Re: 10 Herbert Street, Beacon, New York
Site Plan Application – Responses to Comments

May 24, 2021

Below please find our responses to the comments included in John Clarke Planning and Design's Memorandum, dated April 8, 2021, and Lanc & Tully's letter dated April 9, 2021.

Sheet 1 of 4 - Site Plan

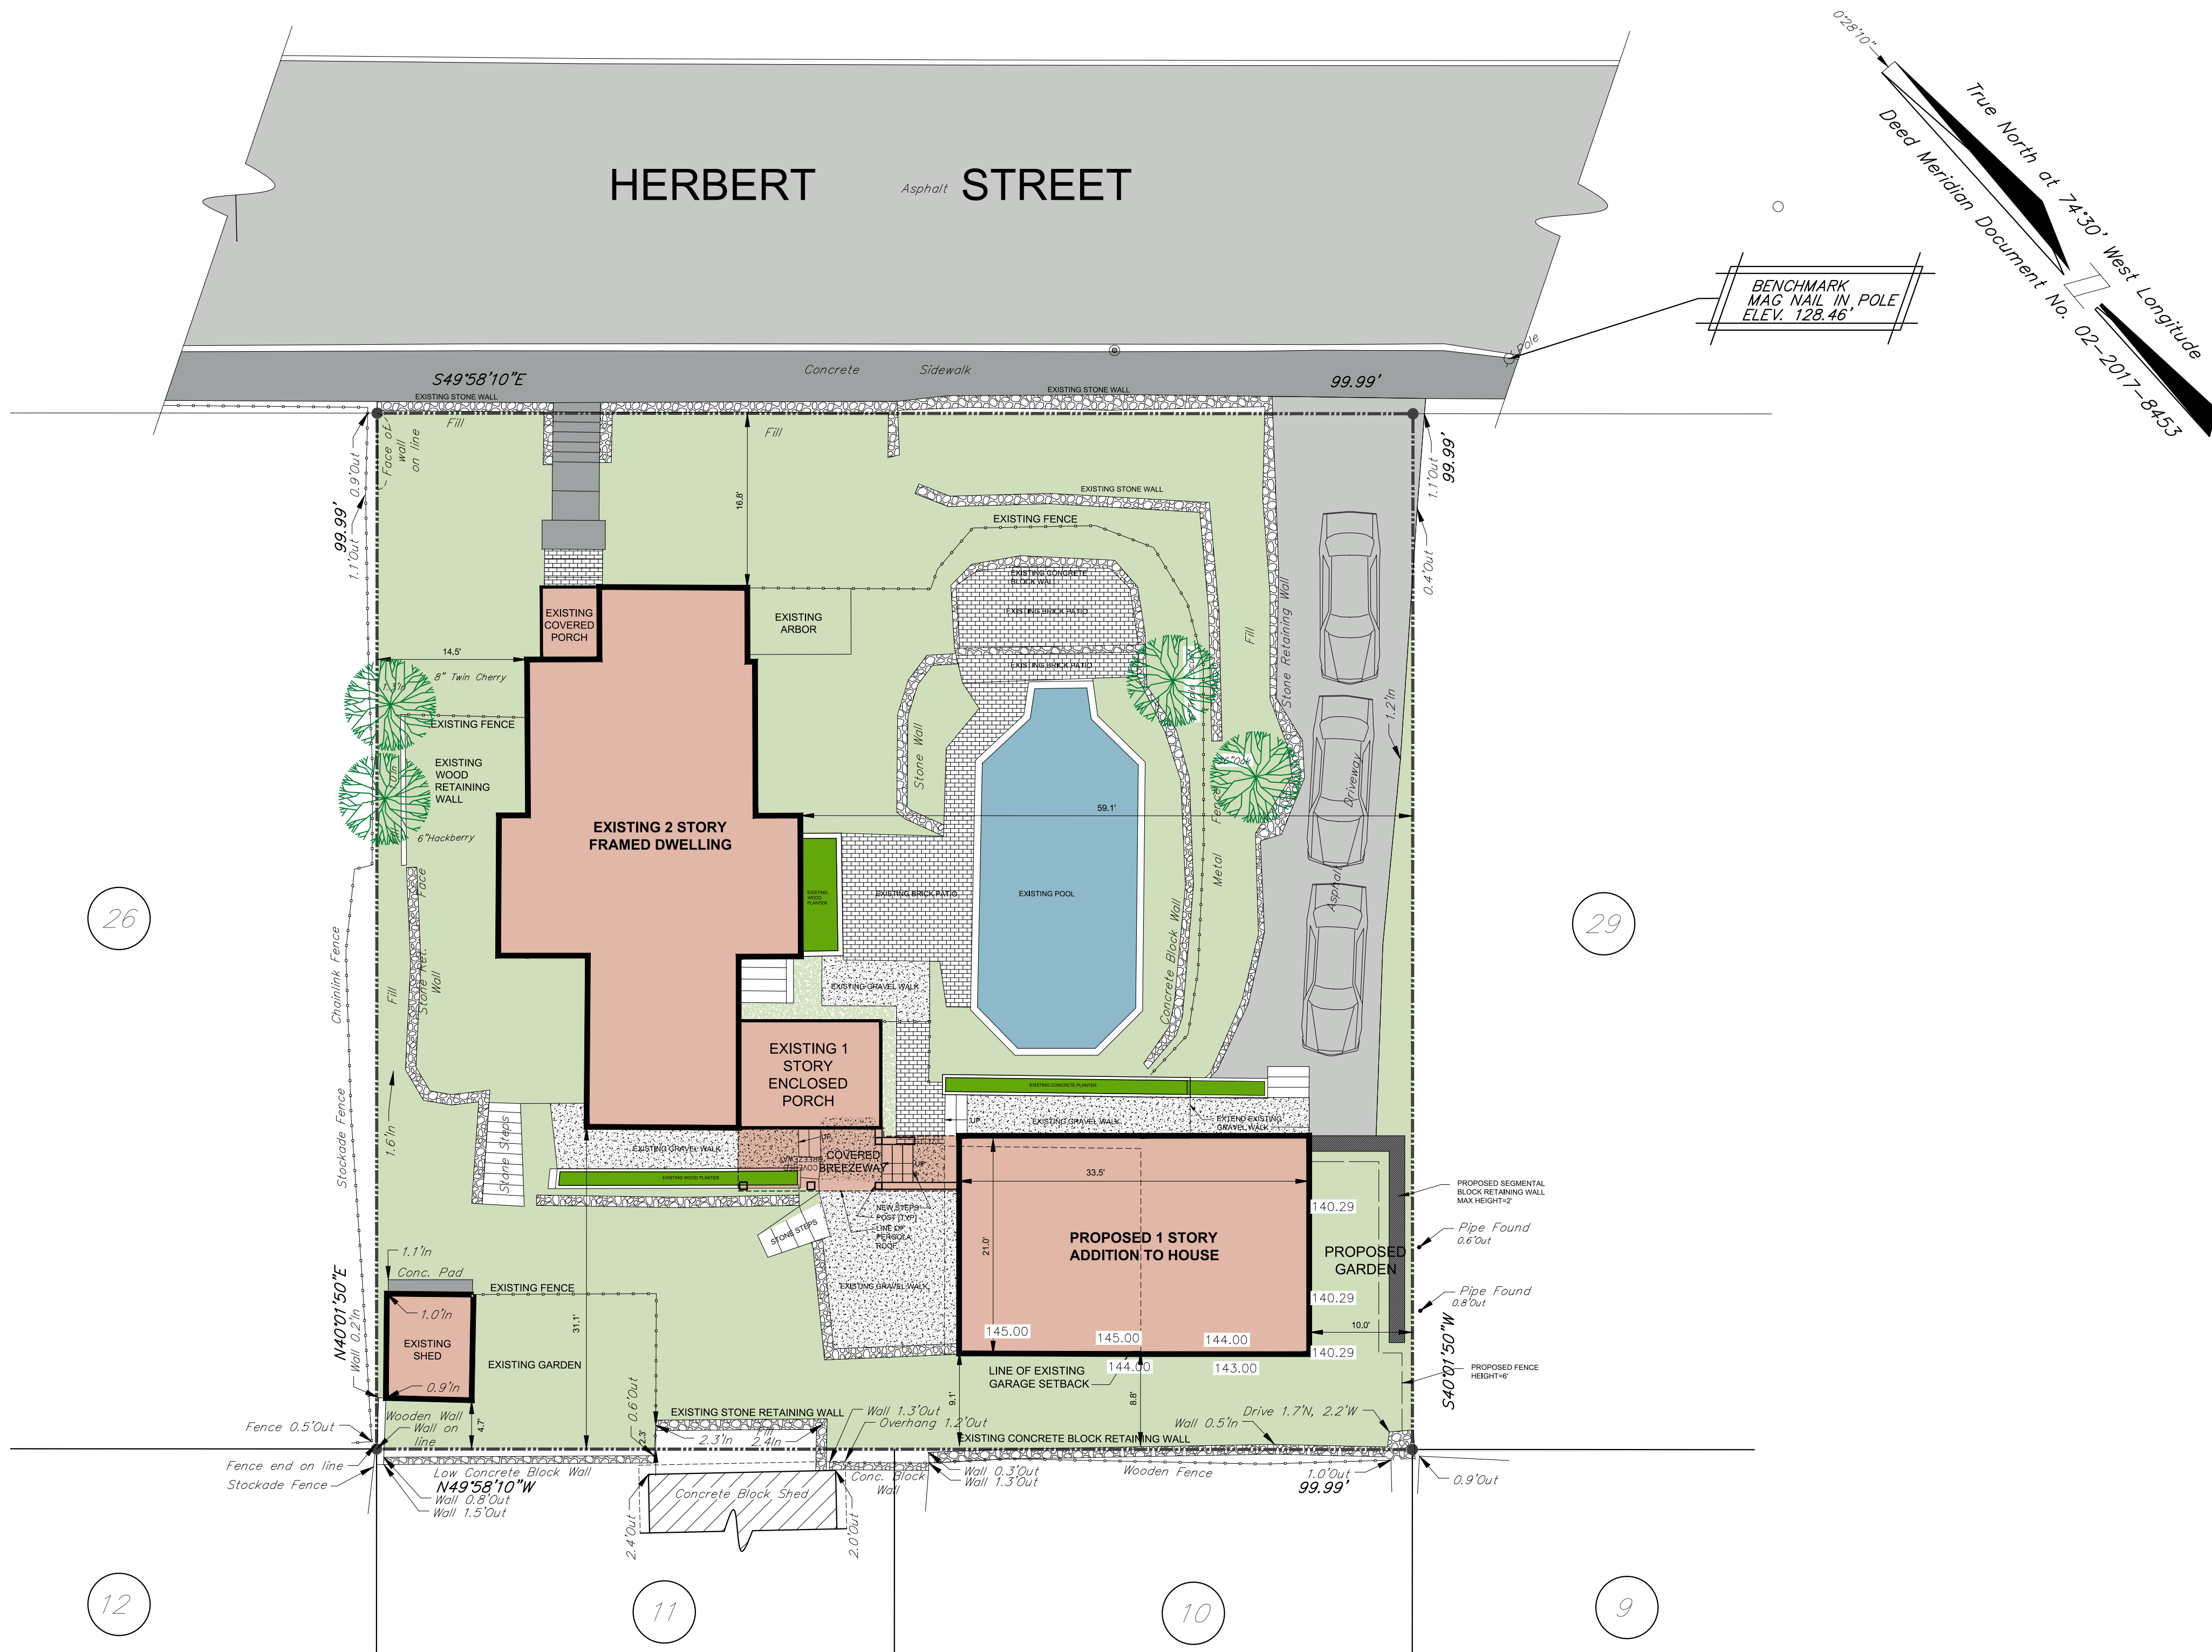
1. For Sheet 1 – Site Plan:

- a The zoning table has been updated to reflect the proposed addition and setbacks
- b The zoning table has been updated to reflect the proposed addition and setbacks
- c The site plan include notes about compliance with the Accessory Apartment
- d Regarding the parking in the existing driveway, Dave Buckley confirmed that this is an existing condition and that he is not concerned about the exact location of the 3 required parking spaces
- e The fence layout has been updated with the new site plan
- f Exterior lighting will be placed at exterior doors
- g It appears that the proposal will only need a variance to allow the addition to maintain the current existing garage rear yard setback of 8.8 feet. The variances have been minimized per the recommendation of the Planning Board and it appears that only the one variance is required.

GRADING & UTILITY PLAN

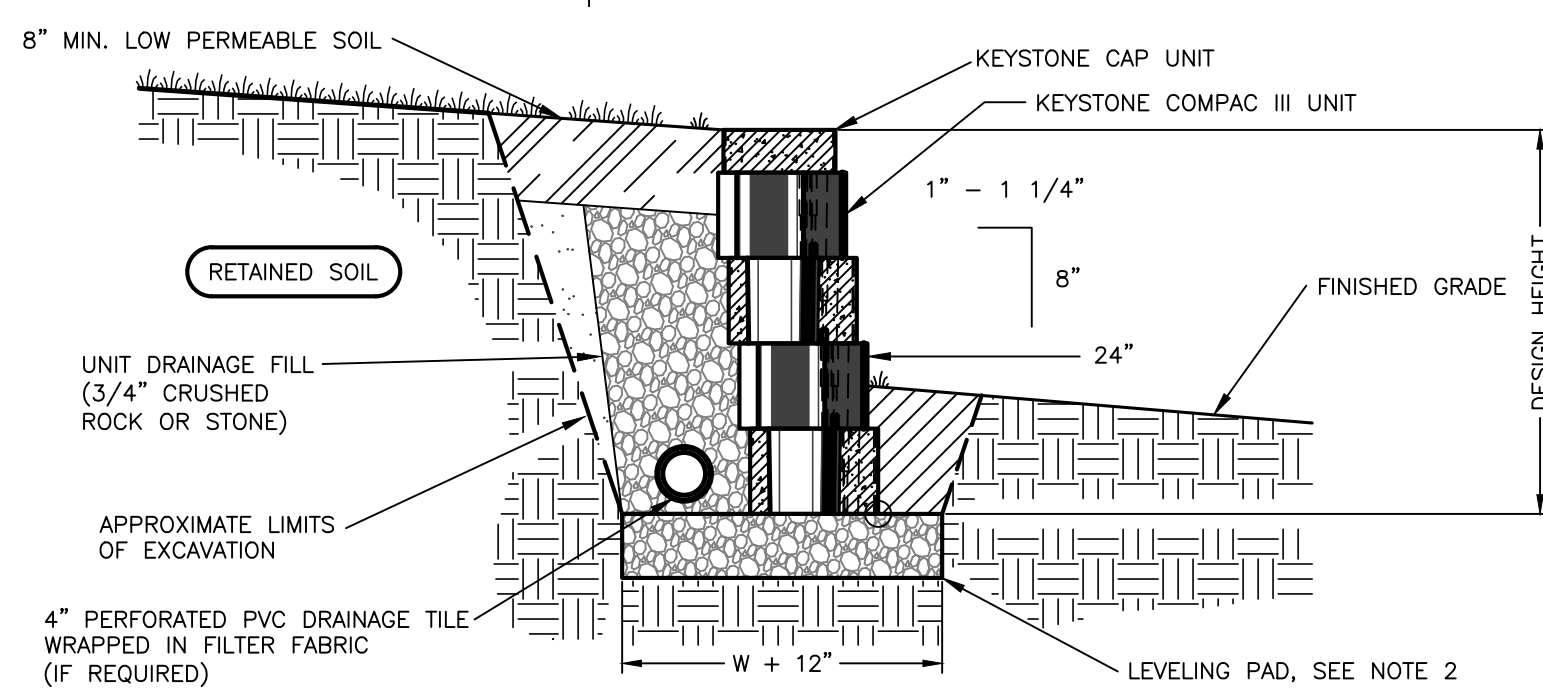
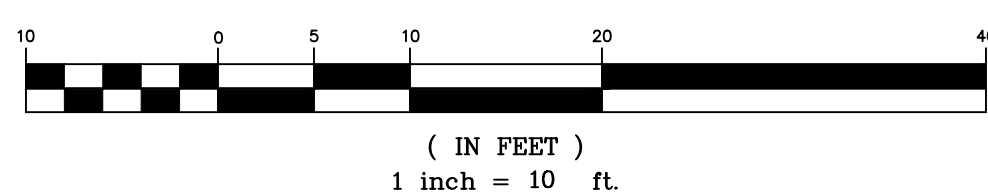
Lanc & Tully Comment Responses:

1. The variances have changed and have been minimized
2. The proposal has changed to a 650 square foot accessory apartment without the additional studio use in another effort to minimize the impact of the project
3. The side yard and rear yard setbacks have been revised.
4. A note will be added to the plan regarding the existing driveway encroachments
5. Approximate locations of water and sewer services to the existing dwelling are shown on Sheet 4. The proposed addition will share the utility connections of the existing dwelling, no new connections are proposed to the City mains in Herbert Street. Construction details of the utilities connections to the existing dwelling are shown on Sheet 4.
6. The surveyed location and invert depths of the sewer main, as well as the approximate location of the water main in Herbert Street are shown on Sheet 4.
